**MEETING AGENDA
SESSION OF THE PLANNING ADVISORY BOARD
CITY OF KISSIMMEE
CITY HALL, COMMISSION CHAMBERS
101 CHURCH STREET, KISSIMMEE, FLORIDA 34741-5054
WEDNESDAY, MARCH 19, 2025 AT 6:00 PM**

Public Hearing - Conditional Use with Site Plan to establish a drive-thru restaurant and retail establishments – 4307 W Vine St - CU-24-0014

**ADDRESS: 4307 W VINE ST
PERMIT NUMBER: CU-24-0014
PROJECT NAME: 4307 W VINE ST REDEVELOPMENT
REVIEW VERSION NUMBER: V.2**

DATE: 02/18/2025
PROJECT NO.:
DRAWN BY: JAC
CHECKED BY: JAC
SCALE: 1" = 30'
SHEET: C-2.0

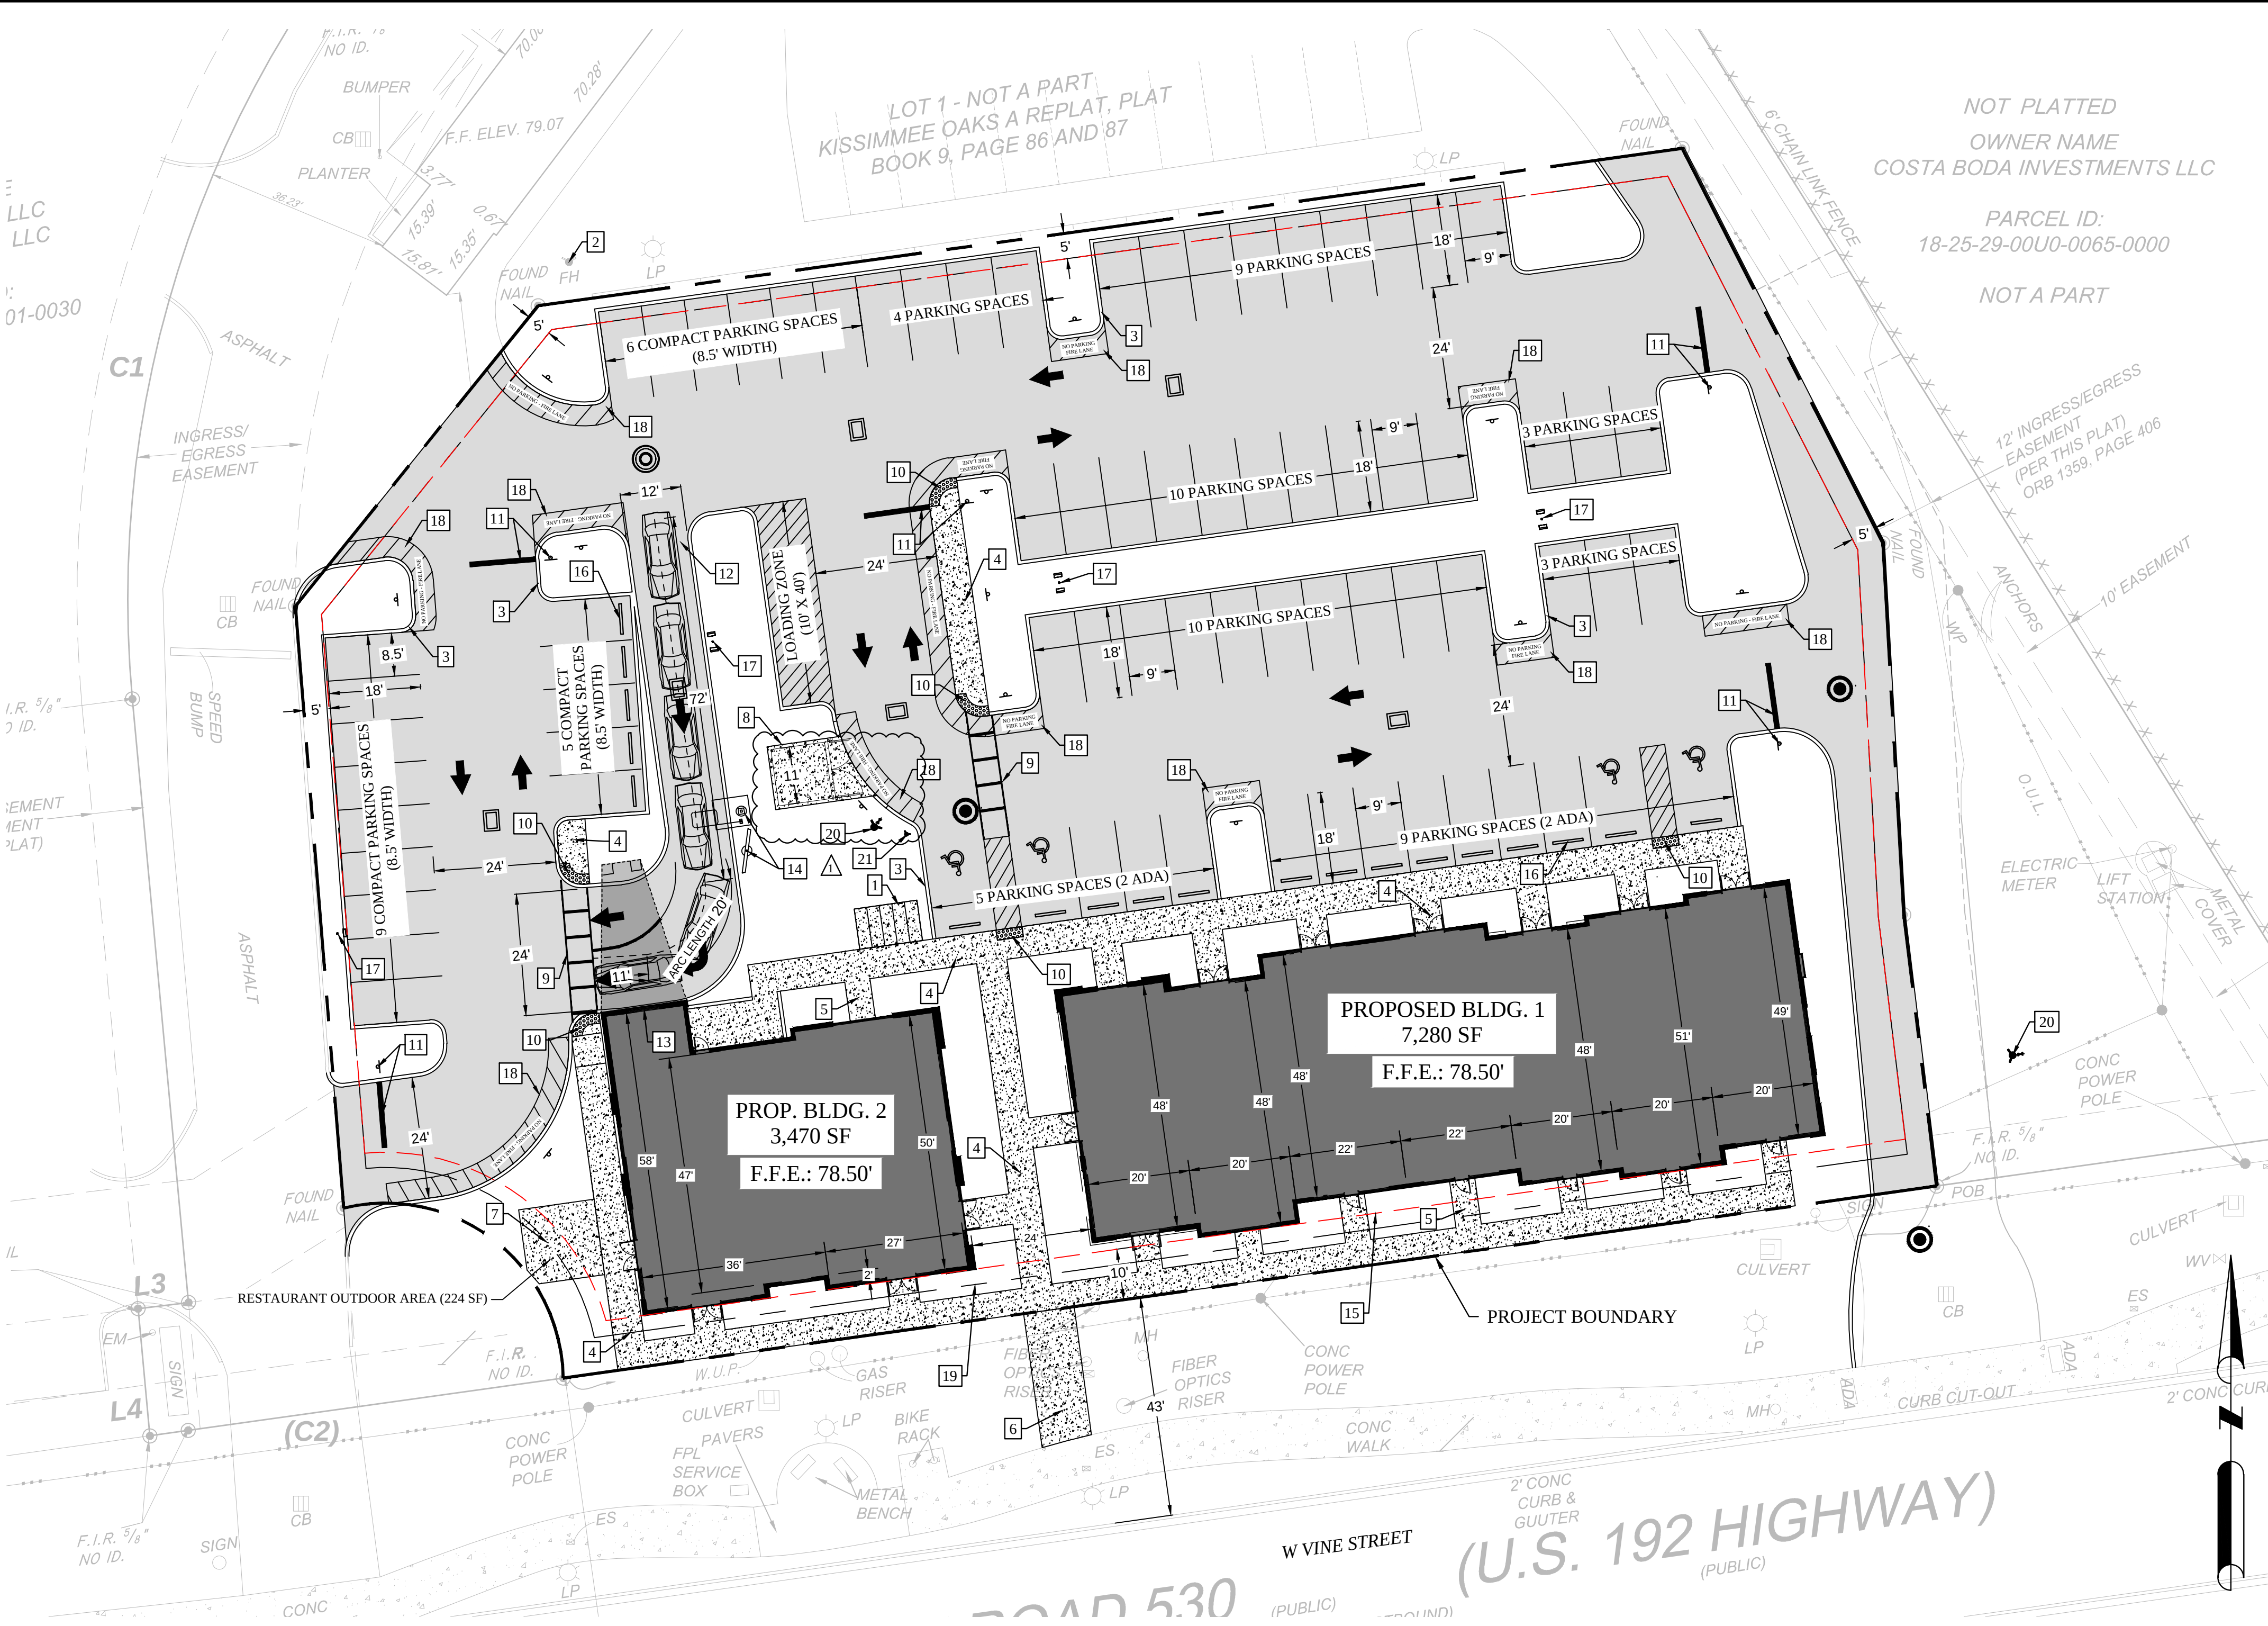
2. Please provide Site dimension information such as buffers, setbacks, drive aisle widths, parking space dimensions, drive-thru stacking dimensions, etc. on the provided Site Plan.

3. Per Section 14-6-40 G "A minimum stacking lane distance of 100 feet shall be provided for each service window. Additional stacking lane distance shall be provided beyond the minimum if warranted by the specific use, as determined by the project's traffic impact analysis/statement, the DRC, and/or the planning advisory board. Stacking lanes shall be designed so that waiting vehicles do not extend into travel lanes or drive aisles, and the stacking measurement shall begin at the service window. Stacking lanes shall be designed to allow waiting motorists to exit to a bypass lane before reaching the service window."

3. Please provide a minimum 24-foot backing distance for all 90-degree parking spaces on the site plan, in accordance with LDC §14-7-23(C), Tables 7-1, 7-2.
4. Please dimension all backing distances on the site plan in accordance with LDC §14-7-23(C), Tables 7-1, 7-2.
 - Two-way: 24 feet
 - Parallel: 12 feet
 - 30-degree: 12 feet
 - 45-degree: 12 feet
 - 60-degree: 14.5 feet
 - 90-degree: 24 feet
5. The minimum standard parking stall width is 9 feet. Ref. LDC §14-7-23(C)
6. Provide minimum parking stall depth perpendicular to drive aisles in accordance with LDC §14-7-23(C), Tables 7-1, 7-2.
 - Parallel: 8 feet
 - 30-degree: 16.8 feet
 - 45-degree: 19 feet
 - 60-degree: 20.1 feet
 - 90-degree: 18 feet

8. Provide dumpster/compactor enclosure inside and approach dimensions on the site plan. Please note: Dumpster enclosure(s) shall be constructed in conformance with City of Kissimmee Construction Standards and Specifications to include a minimum 11-foot inside width and 40-foot unobstructed straight-in approach. Please contact Jody Kirkendall for details: jody.kirkendall@kissimmee.gov

Response: Site dimension information, including buffers, setbacks, drive aisle widths, parking space dimensions, and drive-thru stacking dimensions, has been clearly indicated on the provided Site Plan, see sheet C-3.0.

Response: Stacking lane distances for drive-thru service windows comply with Section 14-6-40 G of the LDC. Provided stacking lane lengths exceed the minimum 100 feet requirement, ensuring adequate space and traffic flow. Dimension of stacking distance has been included on sheet C-3.0.

Response: A minimum 24-foot backing distance for all 90-degree parking spaces has been provided on the site plan. Dimensions have been included on sheet C-3.0.

Response: The site plan sheet has been updated to show a minimum 11-foot internal width for the dumpster/compactor enclosure and a 40-foot unobstructed straight-in approach. See revised sheet C-3.0.

DATE: 02/18/2025
PROJECT NO.:
DRAWN BY: JAC
CHECKED BY: JAC
SCALE: 1" = 20'
SHEET: C-4.0

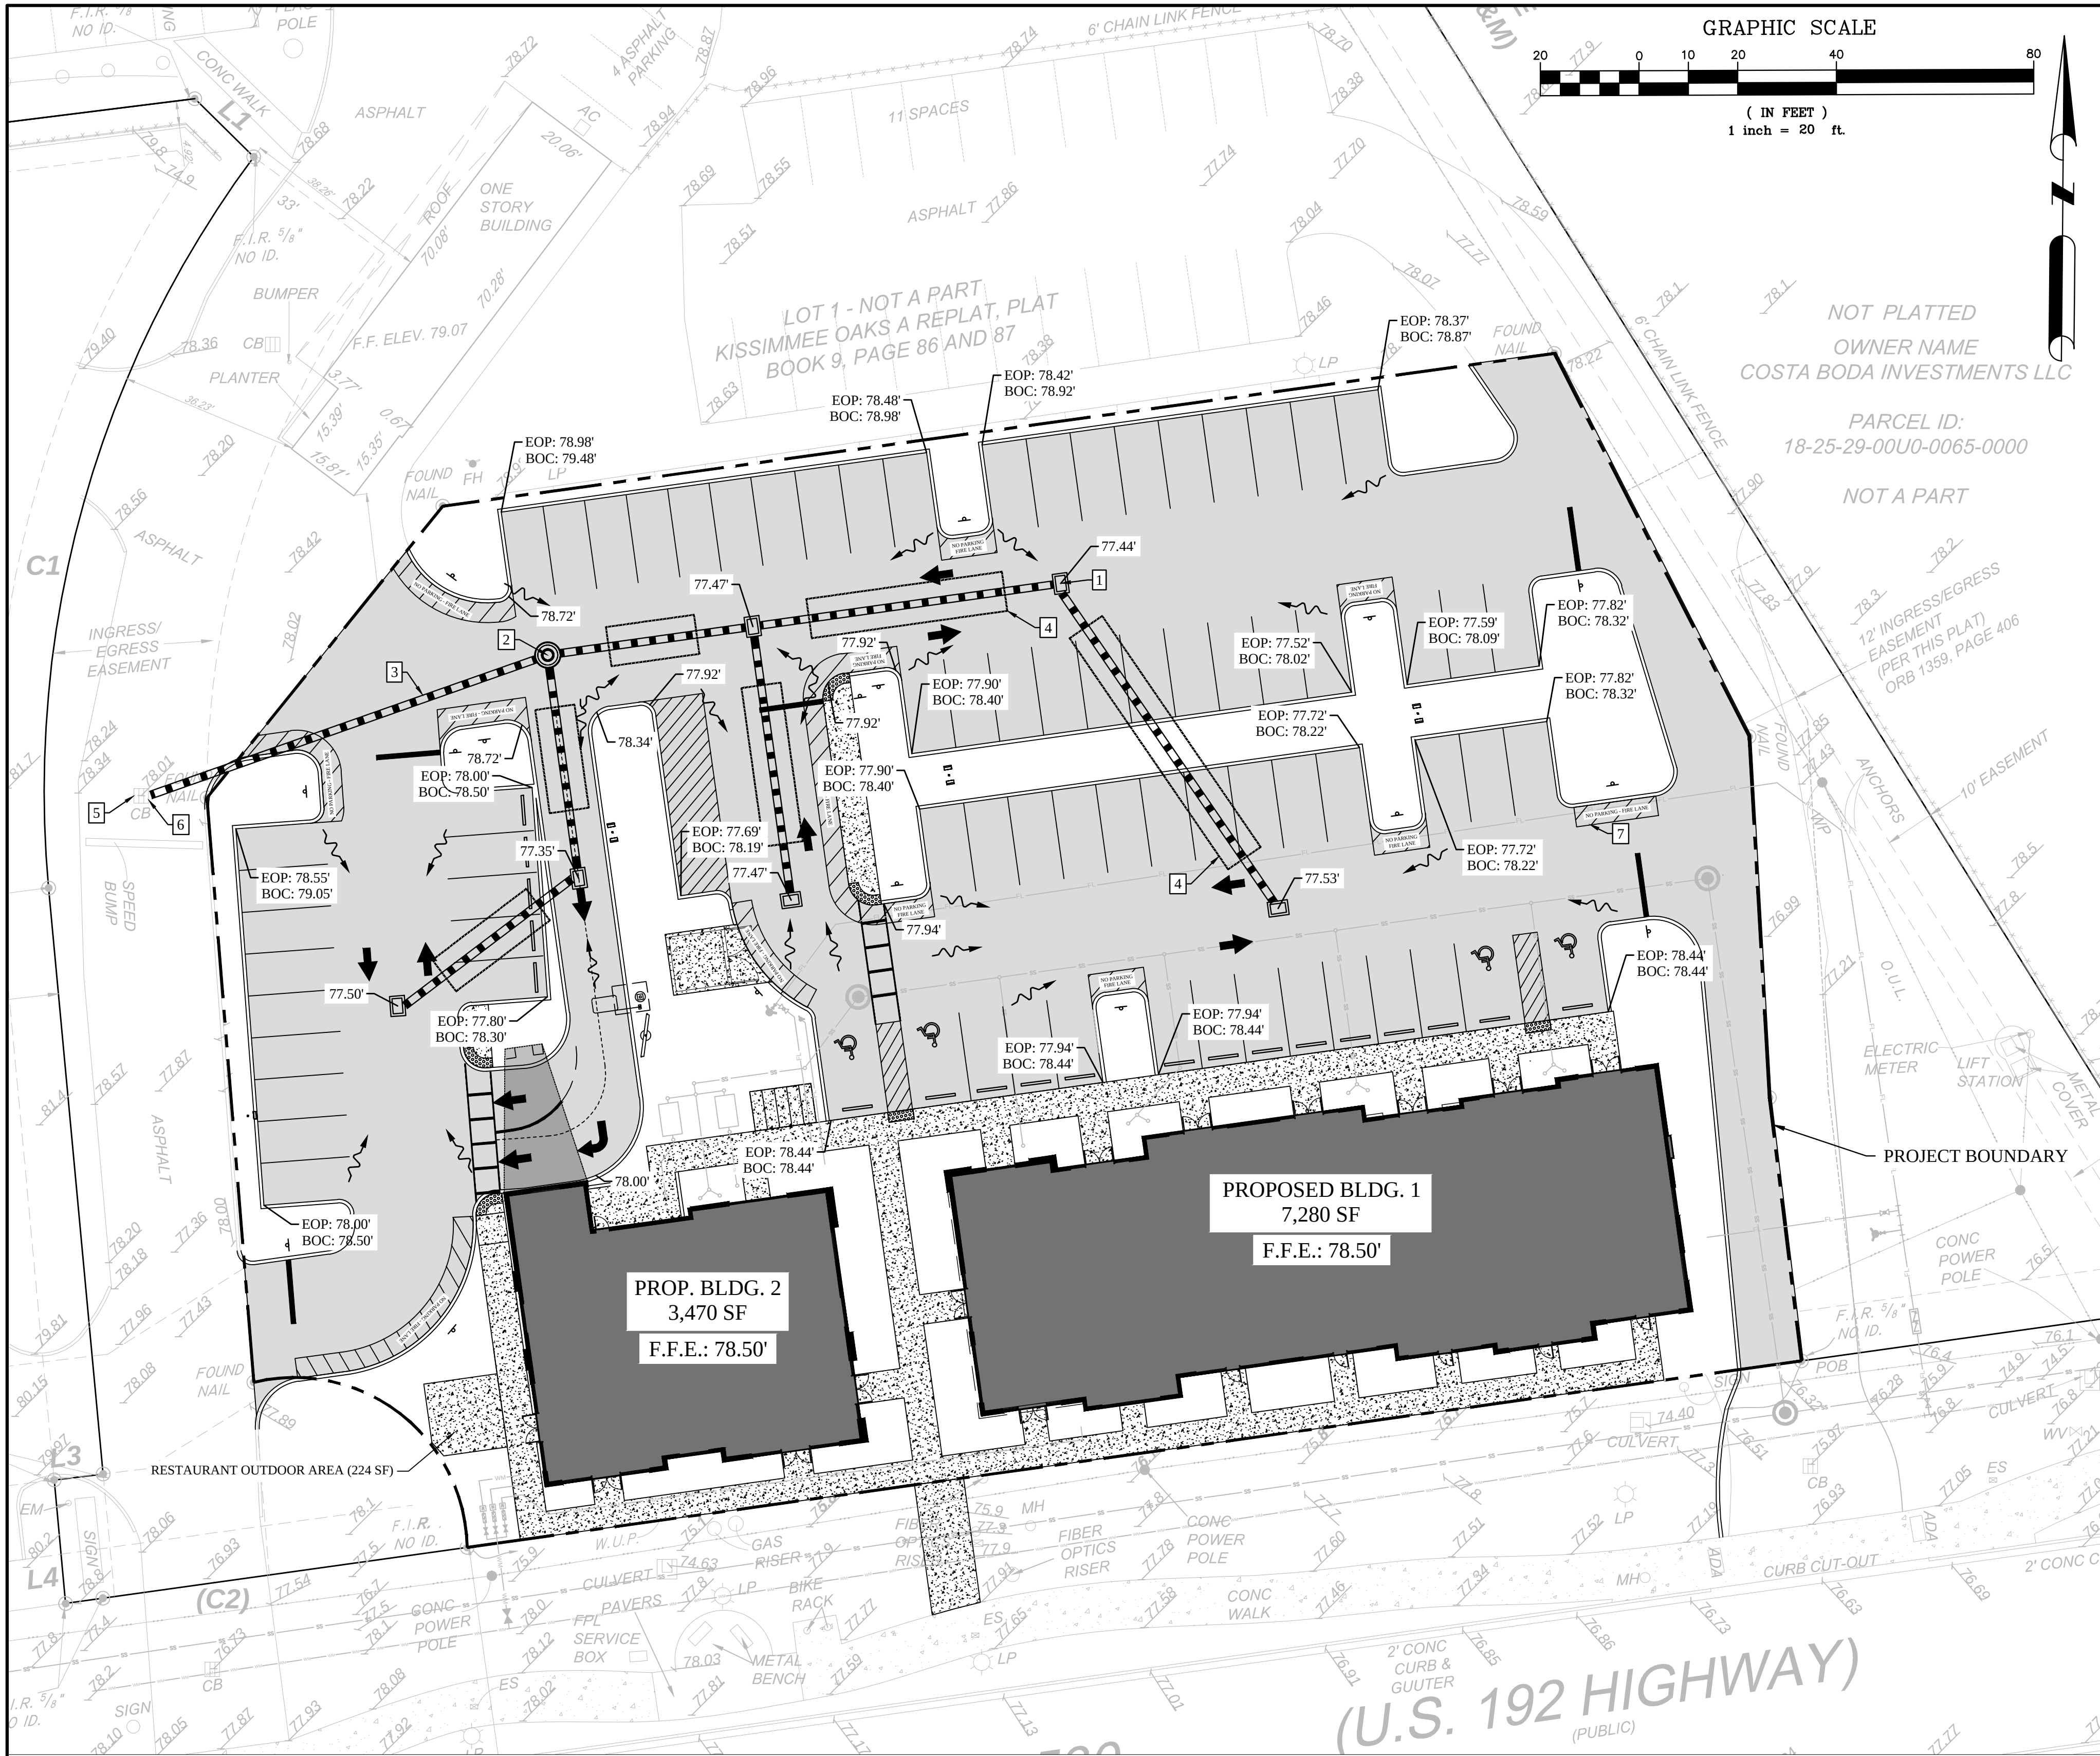
13. All fire hydrants shall have one four and one-half inch steamer and two two and one-half-inch ports. Hydrant outlet threads shall have NH standard external threads for the size outlet supplied as specified in NFPA 1963 Standard for Fire Hose Connections (as adopted by Section 6-1-1 of the Code). The center of the steamer shall be 18 inches minimum above grade. The four and one-half inch steamer shall be turned to face the road or access drive. If the hydrant is on a corner, the steamer is to face the main road or accessway. Provide specs on utility sheet.

the fire hydrant on the same side of the street as the fire hydrant. 2. The marker shall be Model 911A bidirectional 3. Marker size shall be four inches by four inches by three-fourths inch. 4. Marker shall be bonded to roadways by using a two-part epoxy adhesive or other approved material. Provide information on utility plan. 15. Fire Department connections for fire sprinkler systems, standpipe systems, and combined systems shall meet the same standards as those for fire hydrants and undergrounds which are applicable to the FDCs. For NFPA 13 systems, a hydrant shall be placed within 100 feet of an FDC and the FDC shall be a minimum of 30 feet from the building. The FDC for 13R systems shall be located on an exterior wall of the building at the riser with no specific distance from a hydrant. Provide FDC specs on utility sheet along with distance .

Response: Noted. An existing fire hydrant located outside the property boundary at the northwest corner of the will serve the project. Additional fire hydrants have been included to provide support for fire protection. Proposed locations for PIV and FDC have been included. See sheet C-4.0
